197-F-12

Caribou Street

Section 14-403 St. Extension

TO: Jean Fraser  
FROM: Michael Farmer, Project Engineer  
DATE: Dec. 5, 2007  
RE: Caribou Street - Proposed Single Family House Lot

**SITE PLAN/BOUNDARY PLAN**  
EXISTING CONDITIONS  
CARIBOU STREET PORTLAND, ME  
**R. STUART CARTER**

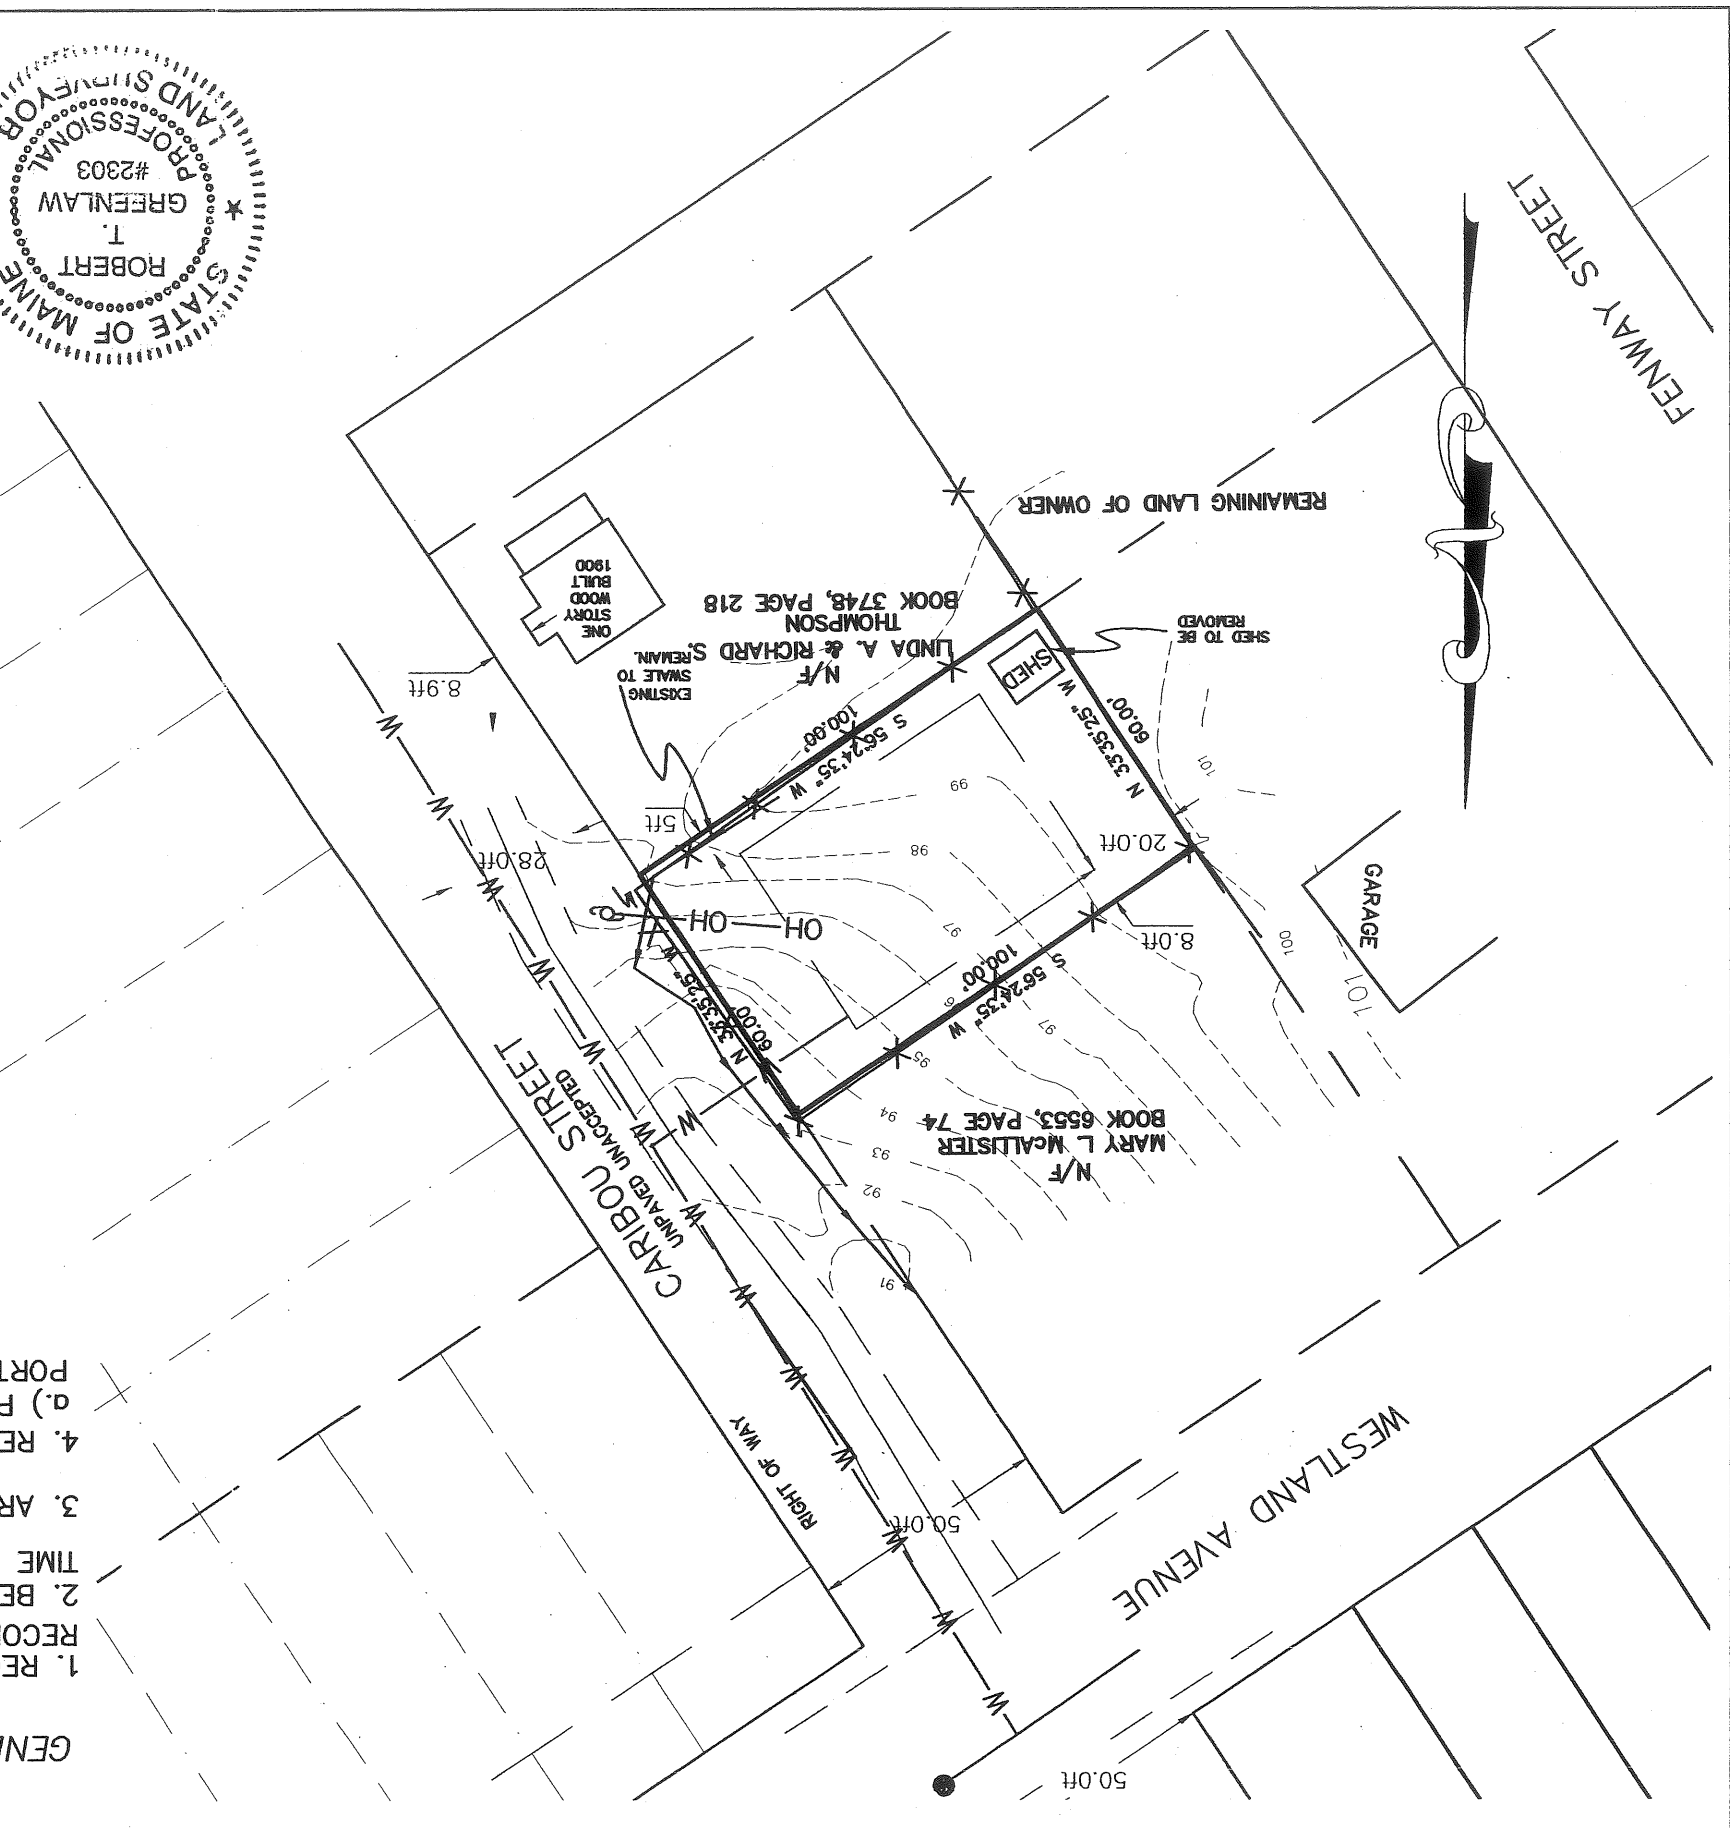
I am submitting the following comments on behalf of the Department of Public Works, based on a review of the 11" x 17" plan dated 6-13-2003, titled SITE PLAN/BOUNDARY PLAN, EXISTING CONDITIONS, CARIBOU STREET PORTLAND, ME.

Section 14-403 of the City Code of Ordinances requires the applicant to build Caribou Street to City standards across the proposed house lot and to build the street (or streets) to City standards from the proposed lot to a permanently paved street. The Department of Public Works has concluded that the closest permanently paved streets to the proposed lot are Hobart Street and Osgood Street. This offers the applicant two possible routes to get from a permanently paved street to the proposed lot.

Improving a street to City standards in this case would include a 28 foot wide paved street with the following utilities: storm drain, water, electric power, street lights, communication, and possibly sanitary sewer. Granite curbing is also generally required; however, Sec. 14-403 allows DPW to waive the requirement for granite curbing in some cases. Section 14-403 indicates that sidewalks may not be required if the street is not on a school walking route. DPW has indicated an inclination to waive the granite curb requirement in this case on parts of Caribou Street and Westland Avenue where the existing roadside ditches and cross culverts function well.

More detailed plans will be required if the applicant pursues this project. An engineered plan and profile design for the street extension is required. A drainage analysis and drainage system design is required. More detailed survey plans are required to show the street areas that will be improved and offered to the City for acceptance. The applicant or his consultants can contact City staff in the Engineering Division of DPW to discuss typical plan details that will be required.

**SITE PLAN/BOUNDARY PLAN**  
**FOR A PROPOSED 1 1/2 STORY RELOCATED HOME**  
**CARIBOU STREET PORTLAND, ME**

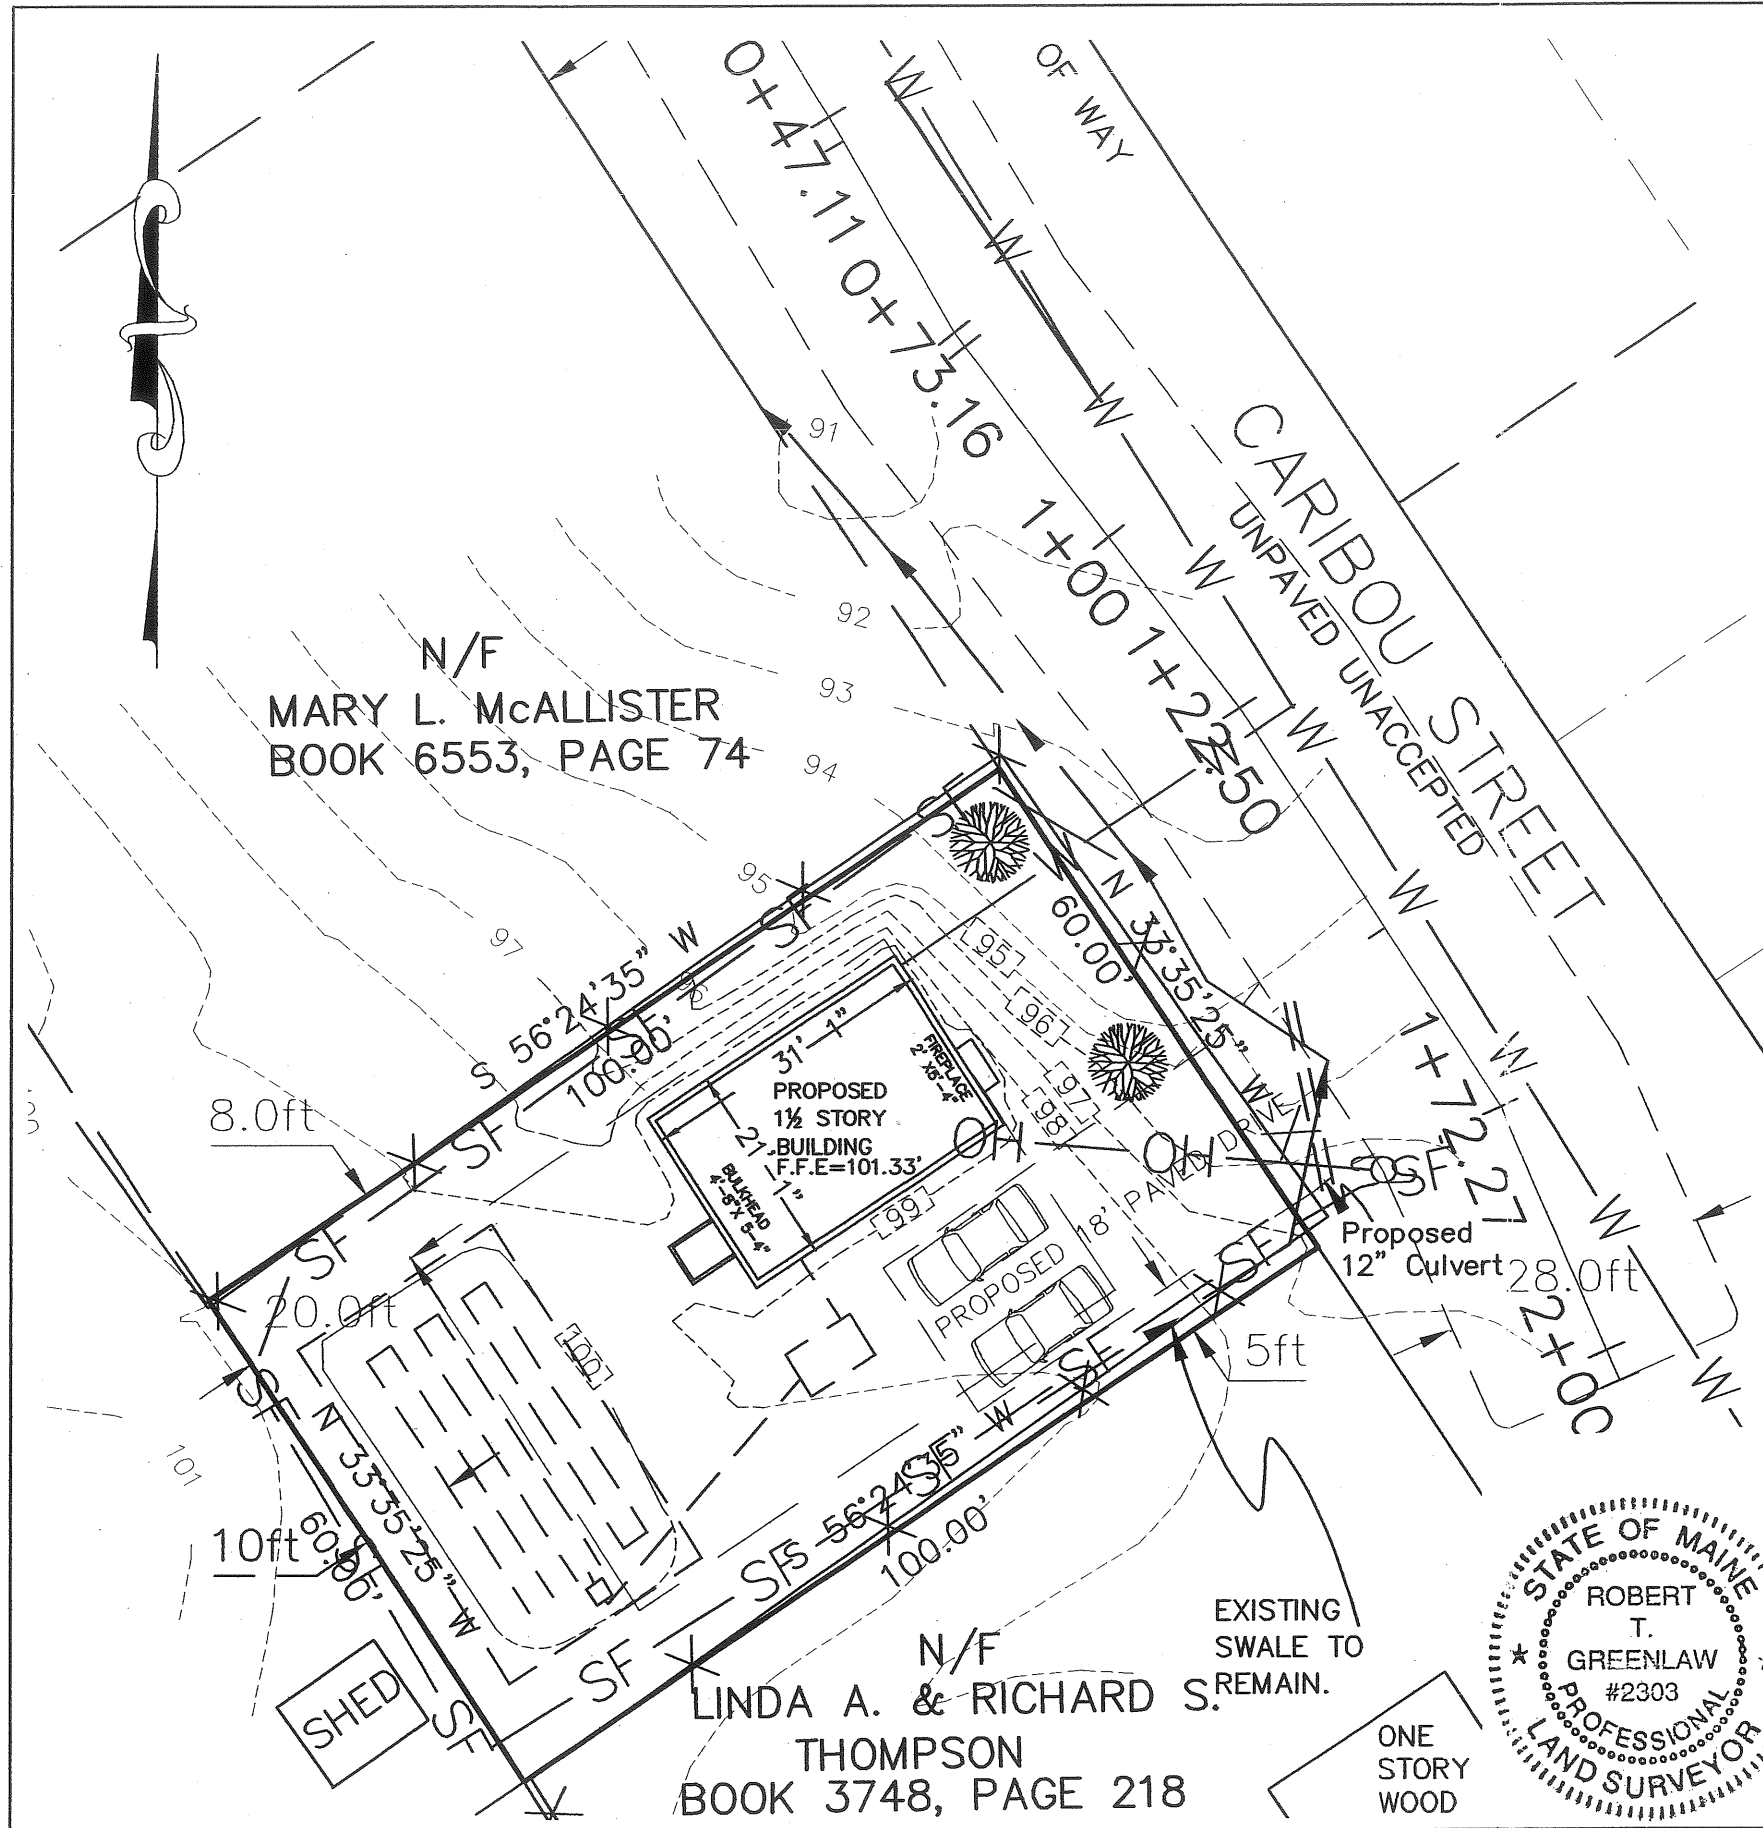
On the plans I have the side setback is inadequate if it is 2 storeys.

Submitted street drawing - carbon only shows 28'

REVISED 10-16-2007: EXPANDED CARIBOU STREET TO 28 FEET WIDE.
